**RE: Southern Ridge Addition
Sanitary Sewer Analysis**

Southern Ridge Sewer Analysis

CASE NUMBER: SUB 2002-55 -- SOUTHERN RIDGE ADDITION

Curve Plotted Curves for Circular Channel

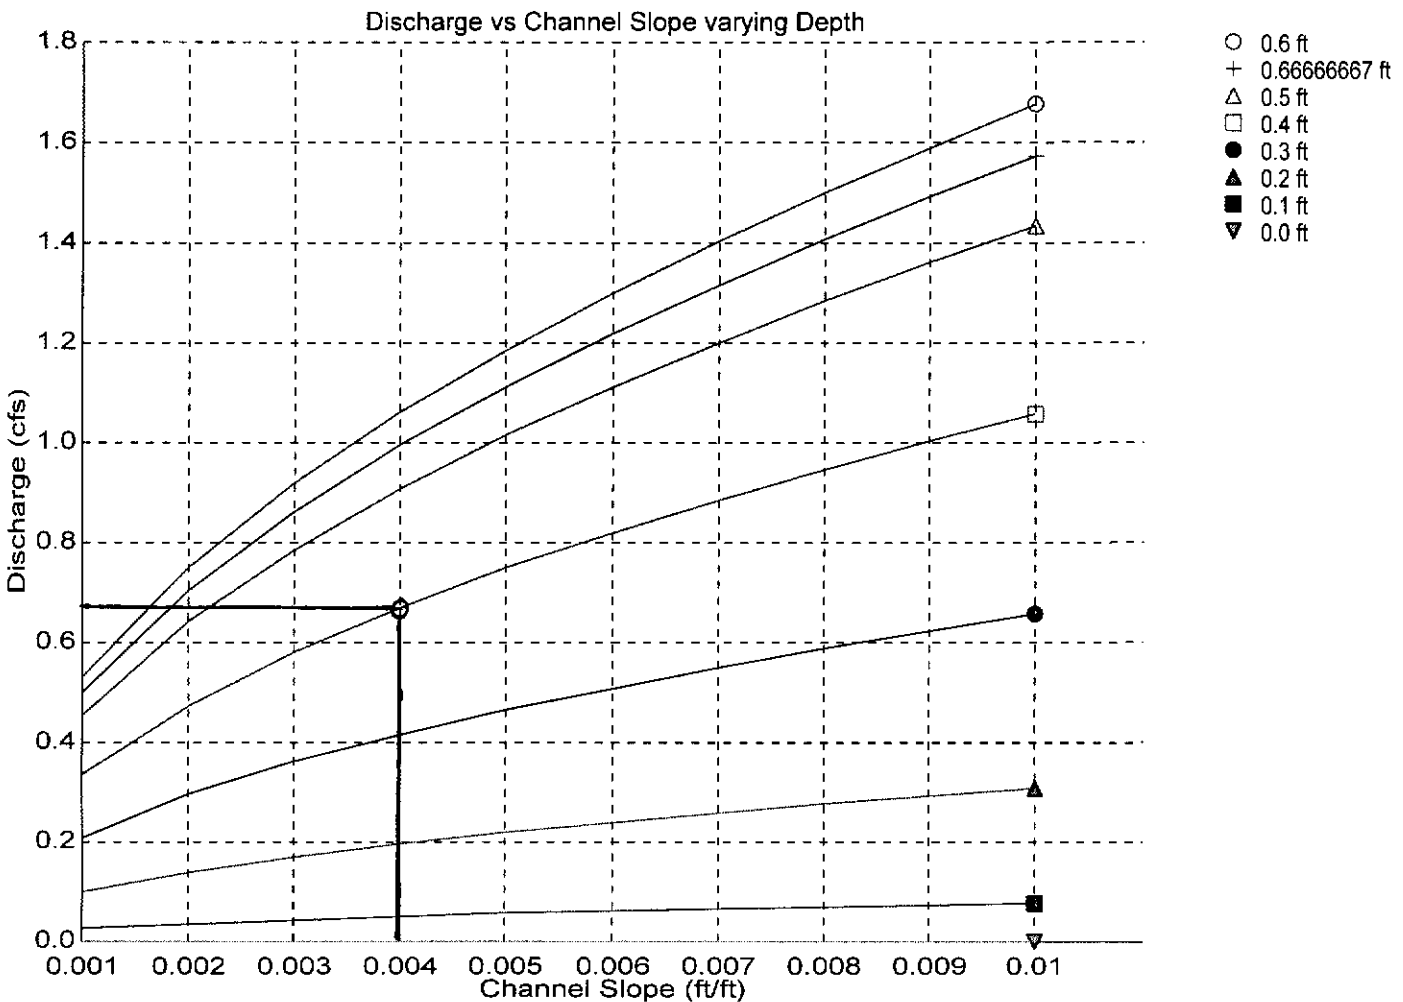
1. Only evaluated Southern Ridge.
2. Used $n = 0.010$, which is fine for brand new pipe. Should use $0.011 - 0.012$.
3. Needs to evaluate the 12" outfall line (0.2% grade and has a double barrel siphon). 12" would serve $2.5 \frac{1}{4}$ sections.
4. Needs to check on previous wet weather surcharges records w/ Sewer Maintenance.
